OIL CONSERVATION DIVISION

Re: Exception to Rule No. 10
Division Order No. R-6199

SUBJECT: REQUEST FOR VARIANCE TO NEW MEXICO OIL
CONSERVATION DIVISION ORDER R-6199 - RULE 10
NORTH HOBBS UNIT, LEE COUNTY

NORTH HOBBS UNIT WELLS
RULE 10 NONCOMPLIANCE

North Hobbs Unit 19-411W
as of April, 1991

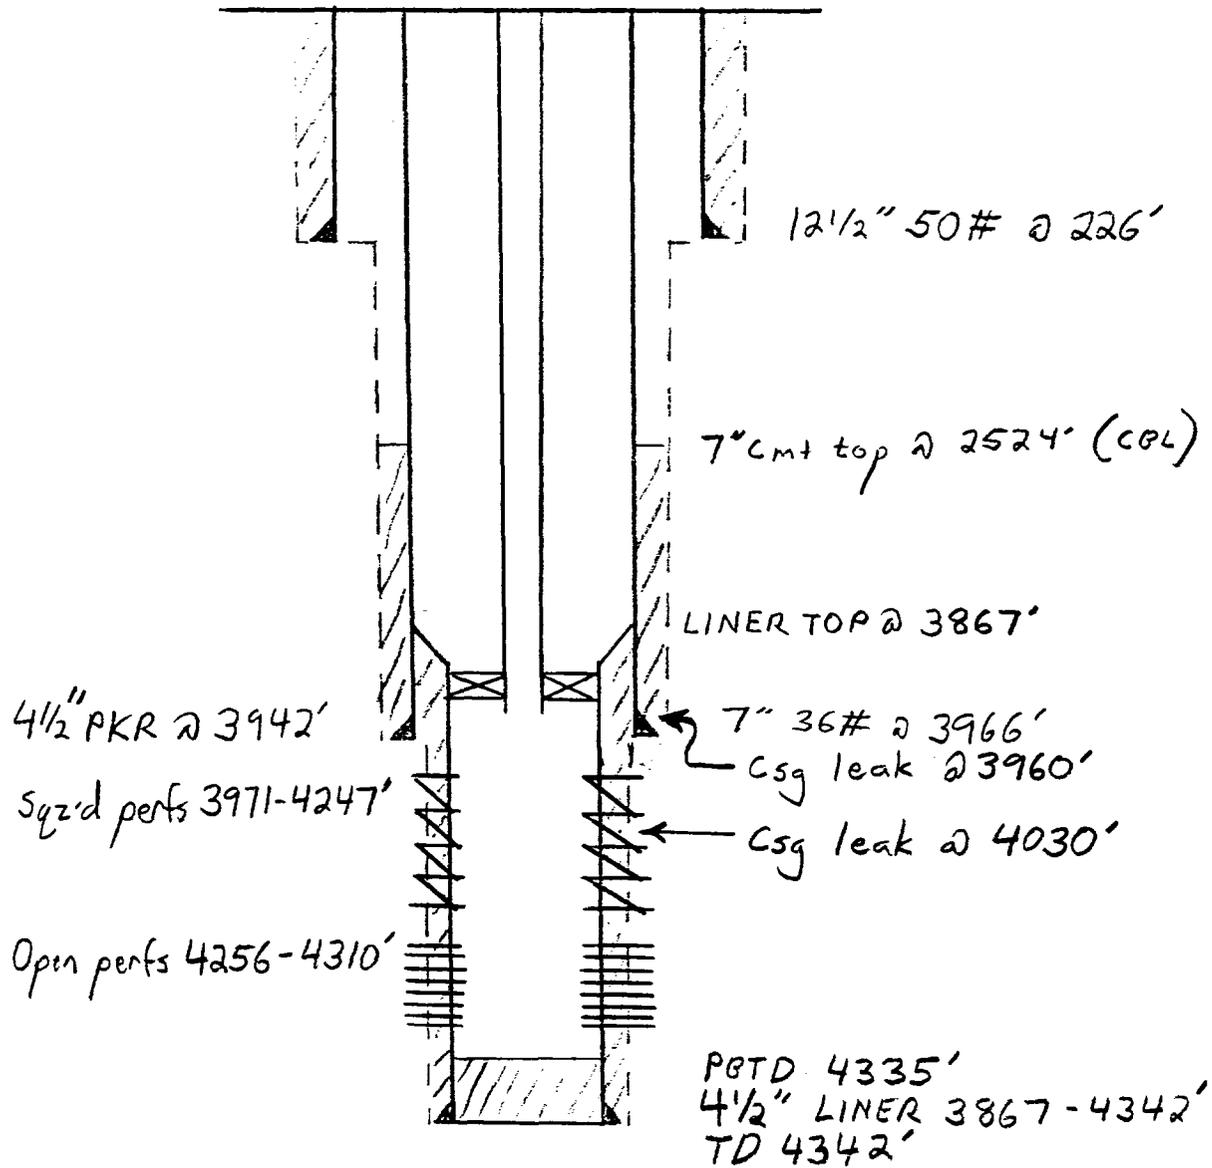
Well No. 19-441W - Packer is set immediately above old cement squeezed perforations. These perforations will not hold a sustained pressure; however, pressure bleed-off is so slight additional cement squeezing is not practical. See Attachment B for a wellbore description.

You are hereby authorized an exception to Rule No. (10) of the Special Rules and Regulations for the North Hobbs Grayburg San Andres Unit Pressure Maintenance Project for the 31 wells shown on Exhibit "A" attached hereto.

North Hobbs Unit 24-442W
as of April, 1991

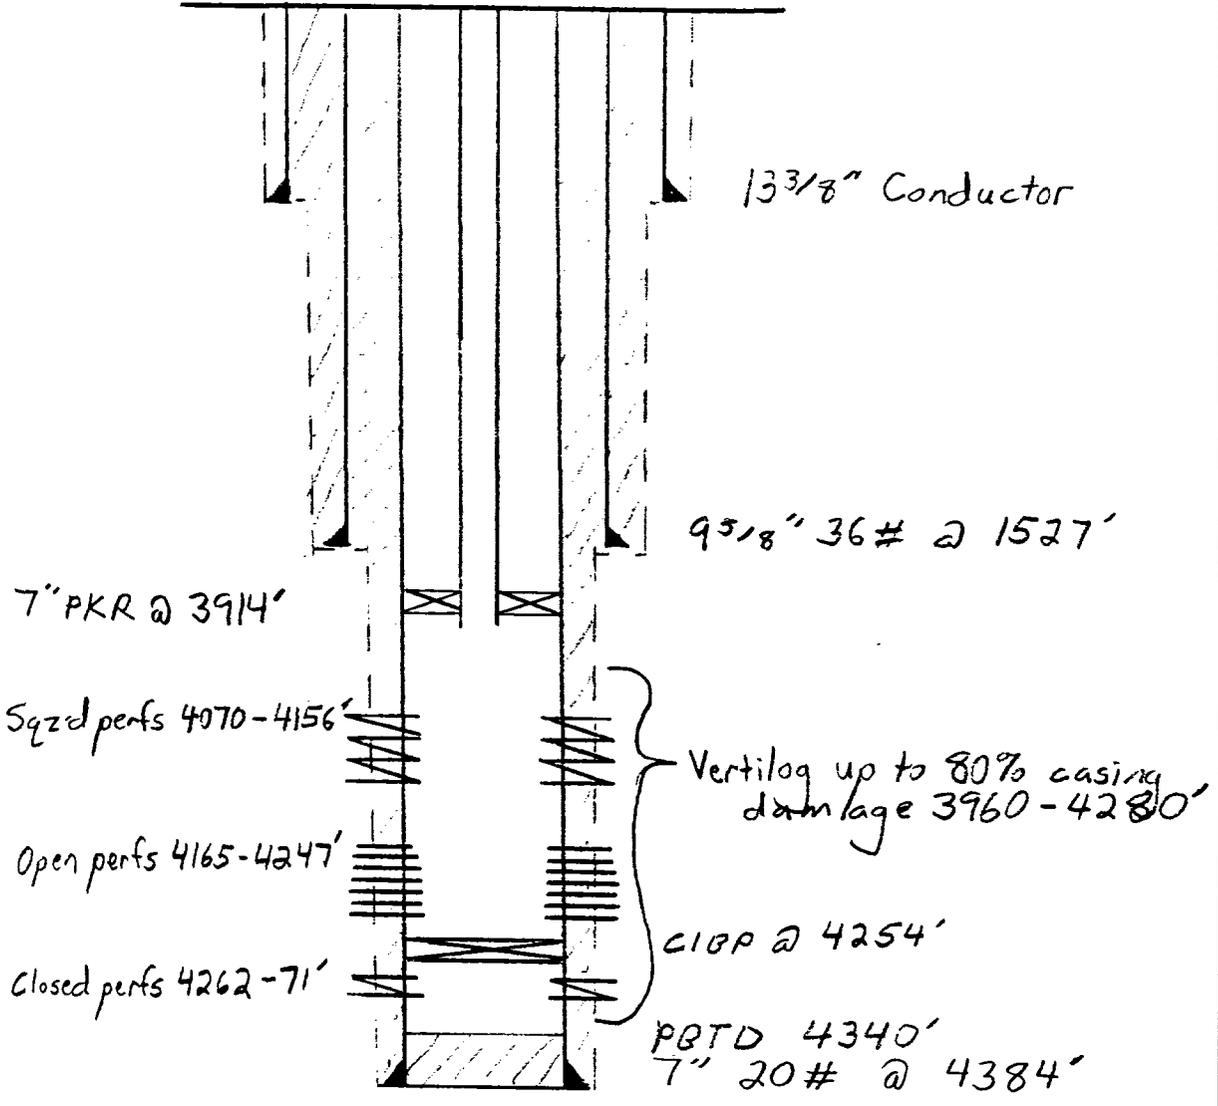
Well No. 24-442W - Packer is set immediately above old cement squeezed perforations. A casing evaluation log (Vertilog) indicated 80% casing loss as high as 3960 feet, 205 feet above the perforated injection interval; therefore, a casing packer could not be expected to seal in this casing loss interval. See Attachment C for a wellbore description.
